SUBJECT: Five-Year Review Report
Motorola 52nd Street Superfund Site, Phoenix, AZ

RE: 5-year Review of Operable Unit 1, Motorola M52 Site

RE: Motorola 52nd Street
Operable Unit Effectiveness Report, 1993
dated September 1994

RE: Motorola 52nd Street Operable Unit Effectiveness Report, 1992

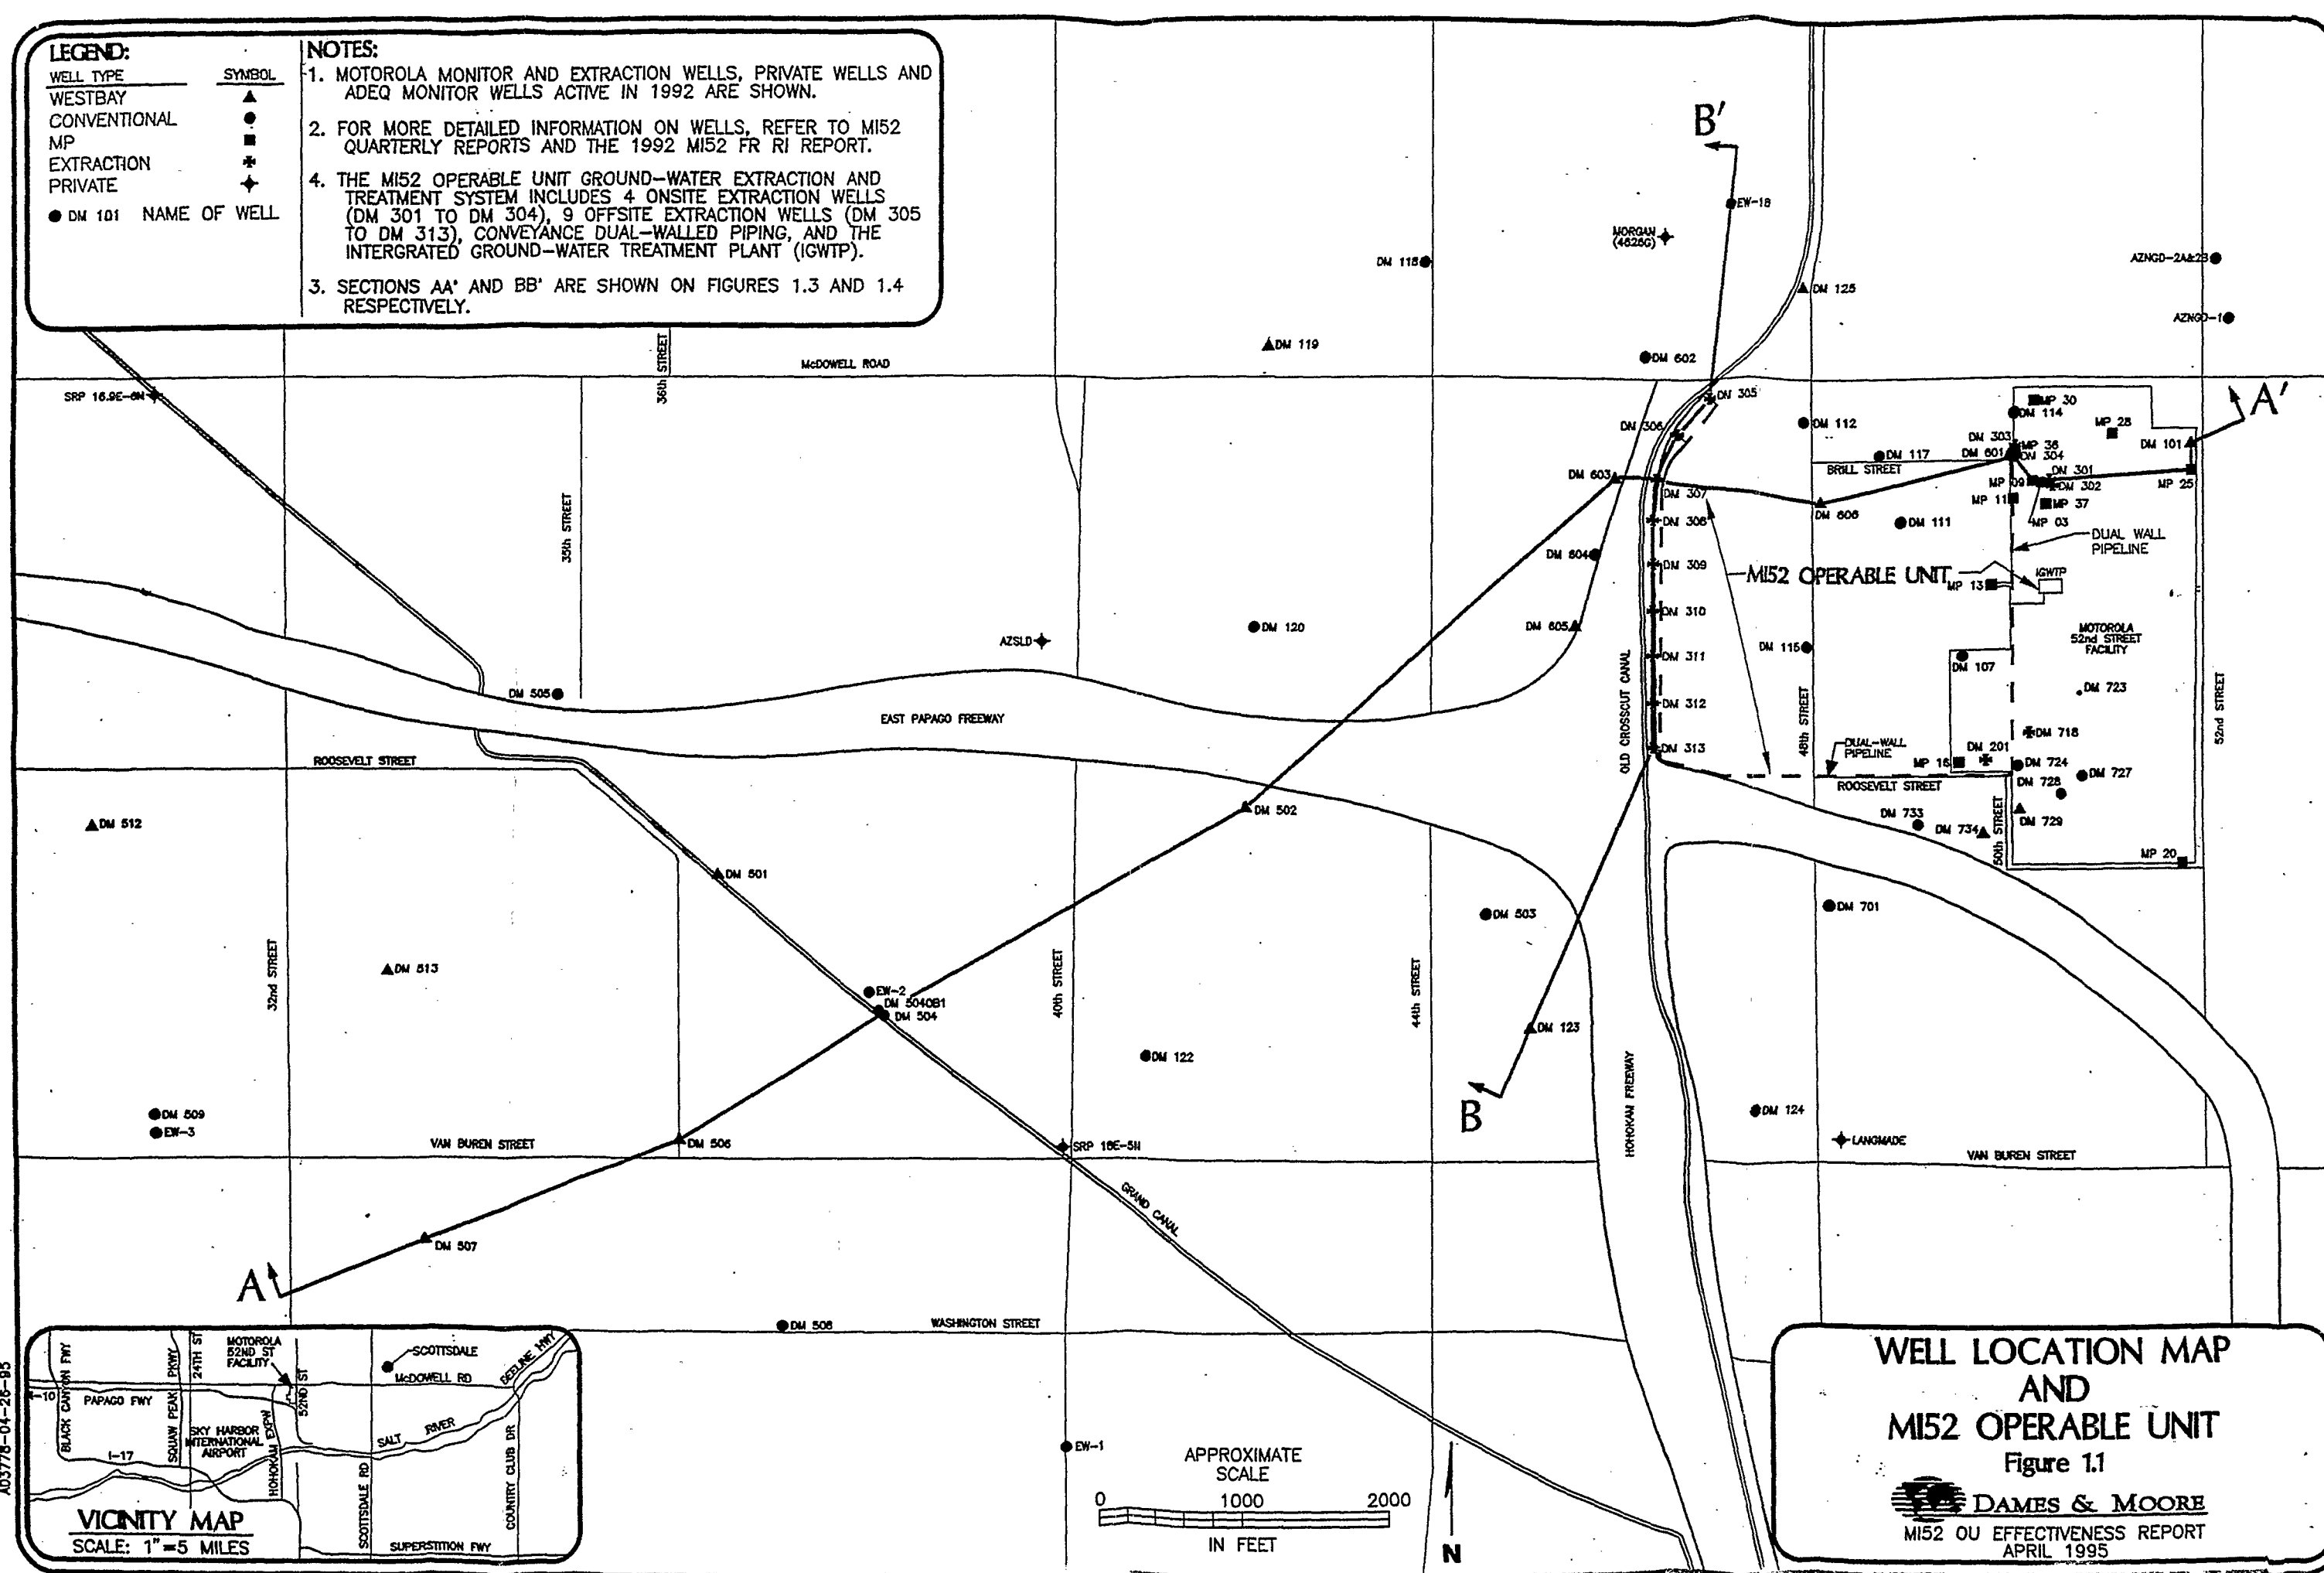
There is currently some question as to whether the hydraulic capture wells are effective in containing contaminants migrating down gradient from the facility. Monitor well DM 603 (see Figure 1.1), immediately down gradient of the OU1 capture well field, has had an 40% increase in the concentration of TCE from the sampling port below the bedrock-alluvium interface during the past three quarters, increasing from 8,100 ug/l to 20,000 ug/l. Review of the TCE concentration data from 1991 to present indicates that current concentrations are at a historic high and are more likely coming from a source up gradient rather than being drawn back from down gradient as an artifact of the capture wells of OU1.

At least two conclusions are possible. The first possibility is a nearby undiscovered source of TCE exists near the well. This would appear unlikely, as only the samples collected below the bedrock interface show an increase. A nearby source should have caused increased concentrations in the samples taken from the alluvium as well as those collected from below the bedrock interface.

The second and most likely cause of the increased concentrations of TCE detected in the in the well is migration of TCE from the facility. If this is the case, OU1 hydraulic capture field has not attained complete capture.

Meetings have been scheduled between Motorola and the ADEQ to discuss the TCE concentration increases in DM 603.

Figure 1.2

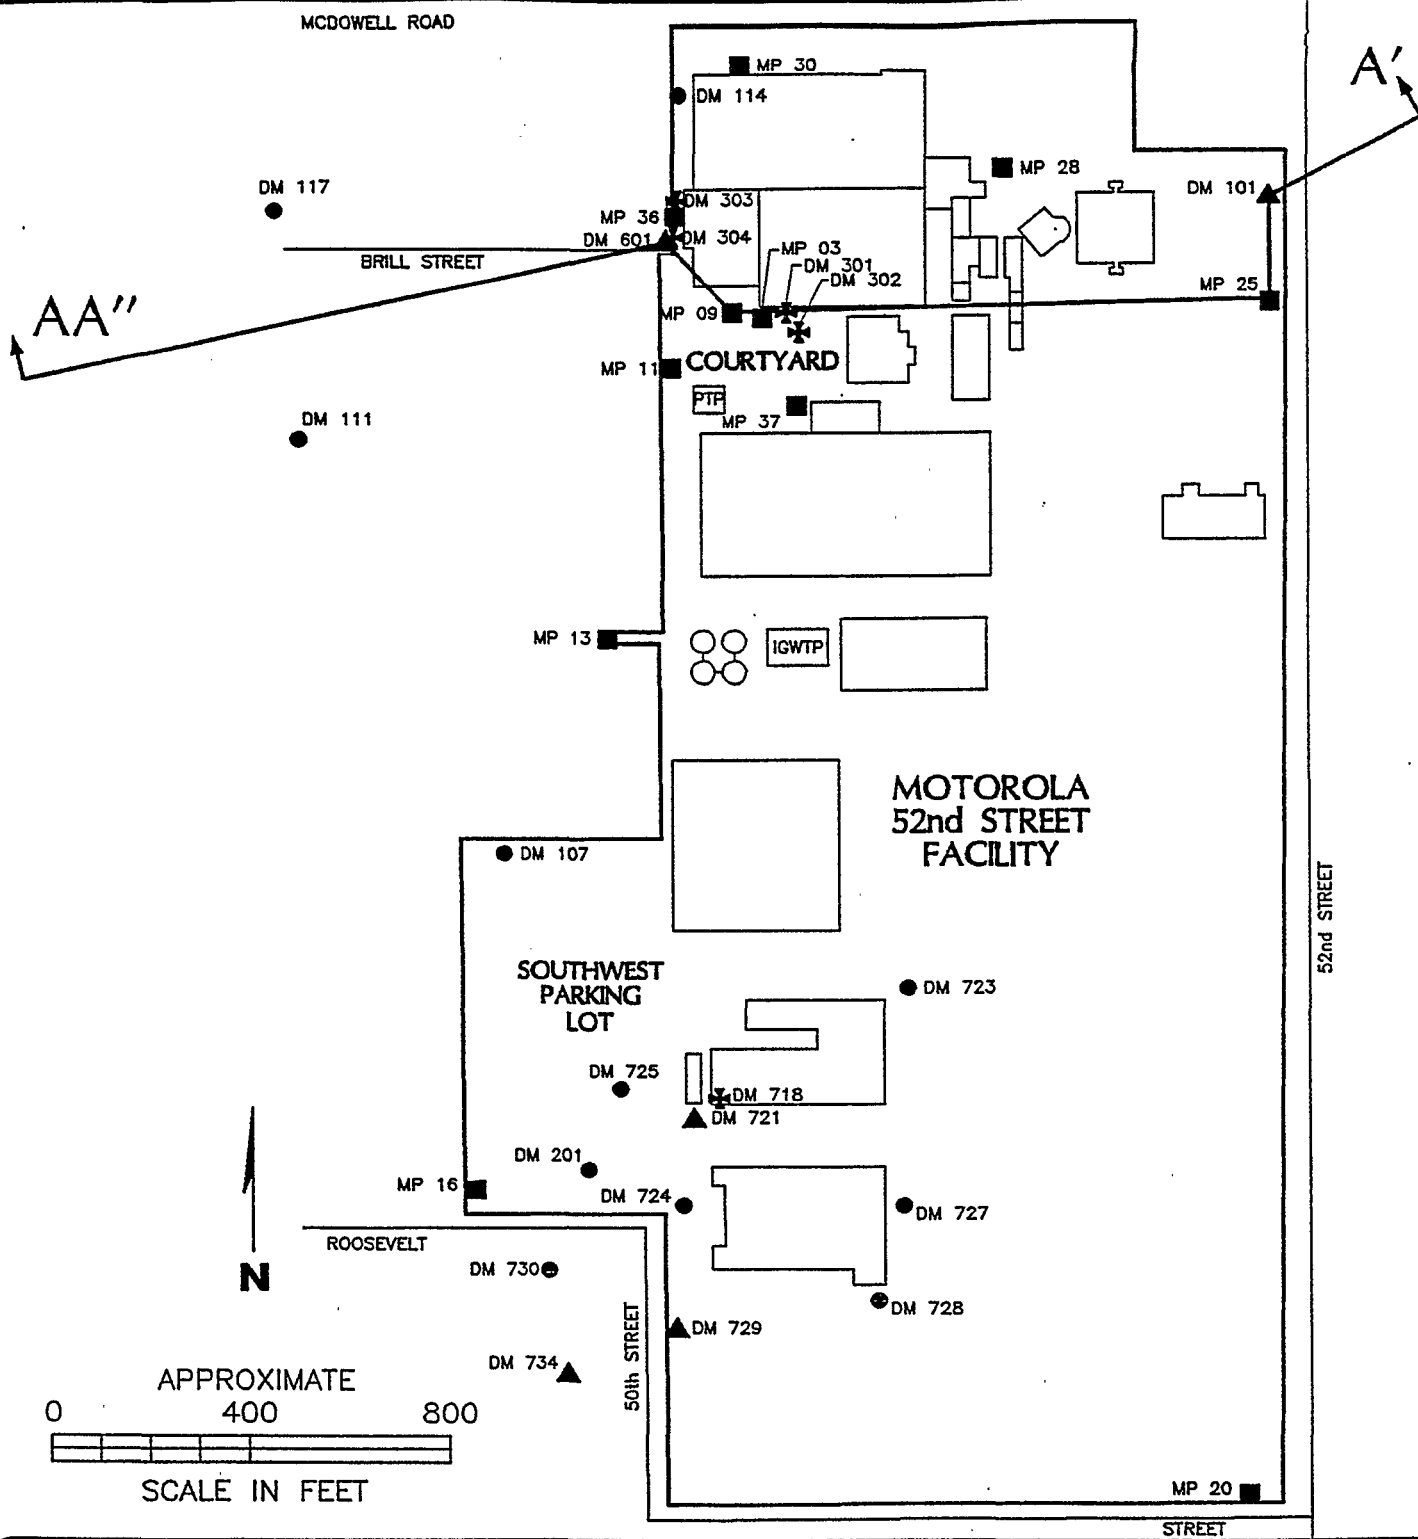
The operable unit remedy consists of 15 on-site and nine off-site extraction wells connected to a ground water treatment plant and a monitoring well network of 68 wells, including 27 multilevel wells. The four on site extraction wells in the courtyard area and 11 wells in the southwest parking lot (see figure 1.2) are used for source removal. The nine off-site extraction wells form a hydraulic containment barrier to prevent further downgradient movement of the contaminant plume to the west. The pilot ground water system began operation in August of 1990 and continued until 1992, when the permanent system began operation. Operation of the permanent system was suspended in June 1993 due to a vinyl chloride air emission problem. The problem was corrected and the system was reactivated in December of 1993.
